**Minutes of the Town of Perinton
Planning Board Meeting of July 16, 2014**

**RE: PRELIMINARY/FINAL SITE PLAN APPROVAL
SITE IMPROVEMENTS AT 347 N. WASHINGTON STREET
MRB GROUP PROJECT NO. 3033.14001.000**

**RE: PRELIMINARY/FINAL SITE PLAN APPROVAL
SITE IMPROVEMENTS AT 347 N. WASHINGTON STREET
MRB GROUP PROJECT NO. 3033.14001.000**

347 N. WASHINGTON ST - LANDSCAPING REVISION
July 16, 2014

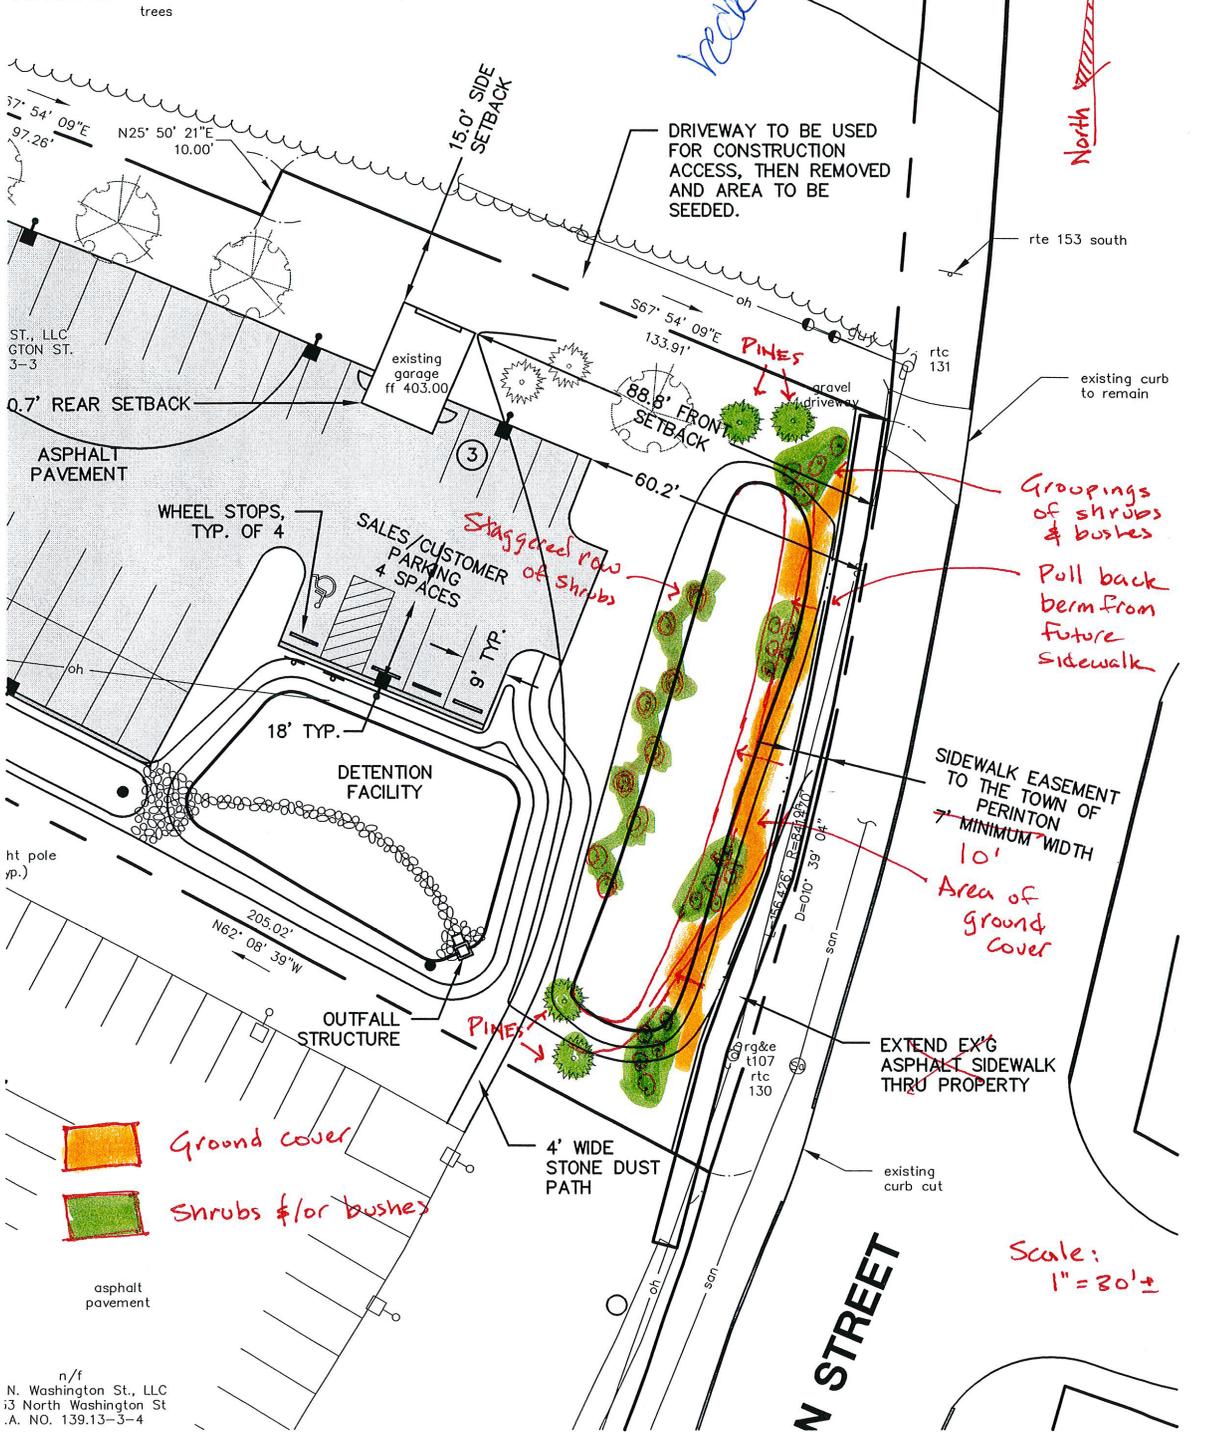
They are proposing up to 6 vehicles within the front setback along North Washington Street. 64 of the spaces are located in the Town of Pittsford. They met with the Pittsford Planning Board on June 16, 2014 and will not be back before them until later this month as they are waiting for a response from the Perinton Planning Board in regards to the lighting and landscaping. The parking lot is currently proposed to be lit by full cutoff LED fixtures – 16’ high mounting heights in the Town of Perinton and 25’ mounting heights in the Town of Pittsford. Pittsford wants the mounting heights to be consistent throughout the development. Dick Ide supports consistency, but asks the Board to consider a taller mounting height in Perinton. The pole heights at the Dick Ide Volkswagen dealership are at 21’ mounting height, and Dick Ide is requesting that the Board consider a 21’ high mounting height for 347 North Washington Street and then they would lower the pole heights in Pittsford to the same height. Pittsford’s other concern was landscaping; specifically the screening of the project from North Washington Street. The project proposes to display vehicles at the top of the berm back to the pines within the front setback. It is their understanding that the parking of vehicles is not permitted within the front setback; however, Dick Ide views this as a display of products, which is permitted for other uses within the Commercial District. Regardless; Dick Ide will eliminate the display, but request that the board consider a change in screening along North Washington Street. Dick Ide is concerned with the security and visibility of the vehicles on the lot and wishes the Board to consider lower lying shrubs and bushes around the base and top of the berm in lieu of the proposed pines.

He submits a proposed revised landscaping plan into the record as shown below.

PLANTINGS TO BE
 REMOVED AND AREA
 TO BE SEEDED AND
 LANDSCAPED.

Mr. Anderson inquired if the berm would be undulating. The applicant states that they can add some undulation. Mr. Anderson feels it is more natural and provides screening. He inquires why they originally proposed pine trees. The applicant states that as the plan progressed they just changed their minds about what would work. Mr. Anderson feels that this new proposal will be better due to security concerns. He asks if the applicant agrees not to park any vehicles in the 50' buffer, and the applicant agrees. Mr. Anderson states that they have the option if they want to shift everything back and stay out of the 50' buffer. The applicant states that they don't want to disturb anymore area than is already disturbed. Mr. Anderson states that he would prefer not to see any cars parked in the front. Parking within the 50' landscape buffer is not allowed. Mr. Anderson inquires how vehicles will be unloaded. The applicant states that there will be no car carriers entering 347 North Washington Street. Mr. Anderson inquired if they would unload on Washington Street, and the applicant states no. Mr. Anderson inquired how this will work if he is a potential customer; where will he park and how will he get around? The applicant states that there are always spots available in front of the Volkswagen buildings. They have offered 4 spaces on this site that will be open. You would have to go through the

Mr. Lewis likes the new landscaping plan. The area between the two rows of shrubs will be what? The applicant states it will be grass. Mr. Lewis is prepared to move forward.

1. Satisfaction of any remaining concerns of the DPW.
2. Final plans submitted to the Town for signature shall reflect the changes as shown on the revised drawing that was submitted tonight, including eliminating the gravel parking lot in the landscape buffer.
3. There shall be no parking or display of cars within the 50' front yard landscape buffer.

4. The berm in the front yard shall be pulled back as shown on the plans submitted to the Town tonight and shown on the final plans submitted to the Town for signature.
